Diamond View Estates 2024; KPB File 2024-040 Geovera, LLC / Sookraj Location: Diamond Ridge Road & Volcano View Court Diamond Ridge Area / Kachemak Bay APC

ITEM #1 - PRELIMINARY PLAT Diamond View Estates 2024

KPB File No.	2024-040	
Plat Committee Meeting:	May 13, 2024	
Applicant / Owner:	Jerome Sookraj of Homer, Alaska	
Surveyor:	Stephen C. Smith – Geovera, LLC	
General Location:	Diamond Ridge Road, Homer Area	
Parent Parcel No.:	173-310-92 and 173-310-51	
Legal Description:	Lot 2-A-1 Diamond View Estates Unit 3 2018 Replat HM 2018-049 and Lot 3 Diamond View Estates Sub HM 80-94	
Assessing Use:	Residential and Vacant	
Zoning:	Unrestricted	
Water / Wastewater	Onsite	
Exception Request	None

STAFF REPORT

SHEET 1 OF 1

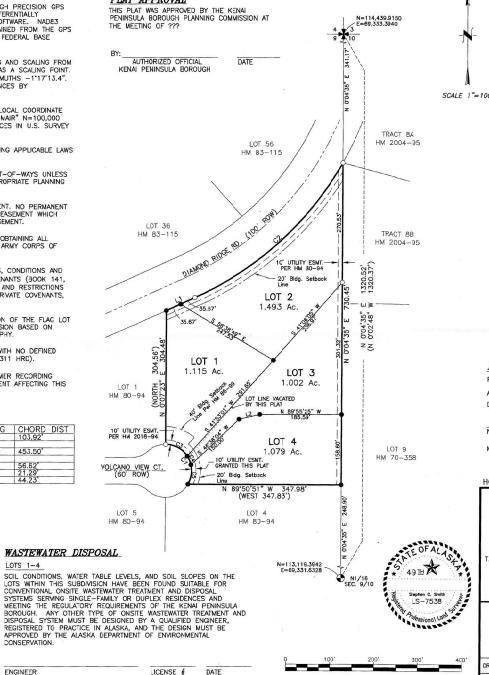
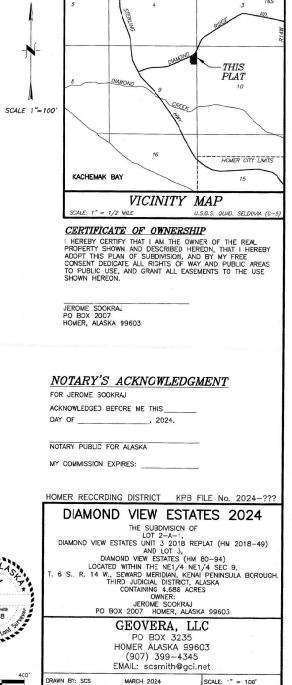
Volcano View Ct. will remain unaffected by this plat action except to make the cul-de-sac. RSA review shows concern that this is a driveway dense cul-de-sac and that an access permit for Lot 2 to Diamond Ridge Rd will be needed.

The 10' utility easement granted per HM 2018-49 to be labeled on plat along border with Diamond Ridge Rd. The 10' utility easement identified along Volcano View Ct. to be labeled correctly as HM 2018-49 on Lot 1 and per this plat on Lots 3 & 4. Draw and label the 10' x 10' HEA Easement per HM 86-99 on the north line near Diamond Ridge Rd also.

HEA	Provide a label for the 10' utility easement granted per HM 2018-49, Correct the reference to plat number 2018-49.
ENSTAR	
ACS	
GCI

Add the KPB file 2024-040 to the title block

There is an existing trail shown on the asbuilt included in the certificate to plat and visible on the aerial photo, this should be added to the drawing and labeled.

J. Block and lot numbering per KPB 20.60.140, approximate dimensions and total numbers of proposed lots; **Staff recommendation:** Lot 3 is within a previous recent Lot 3. Lot 2 similar issue. Consider 3A & 2C possibly

Diamond Ridge property access permitted through AK DOT. Application for driveway access from Lot 2 to state ROW will need to be approved.

Add to the drawing the 10' x 10' utility on the north line against Diamond Ridge Drive as created by HM86-99

Add map panel info

10' utility easement granted per HM 2018-49 to be labeled on plat along border with Diamond Ridge Rd. 10' utility easement identified along Volcano View Ct. to be labeled correctly as HM 2018-49 on Lot 1 and specify that on Lots 3 & 4 for this plat.

- "No access to state-maintained rights-of-way permitted unless approved by the State of Alaska Department of Transportation."
- Add a plat note referencing plat note #4 HM 86-99 to the plat
- The borough will not enforce private covenants, easements, or deed restrictions per KPB 20.60.170.

20.60.190. Certificates, statements, and signatures required. **Staff recommendation**: comply with 20.60.190. Add the date of May 13, 2024 to the Plat Approval
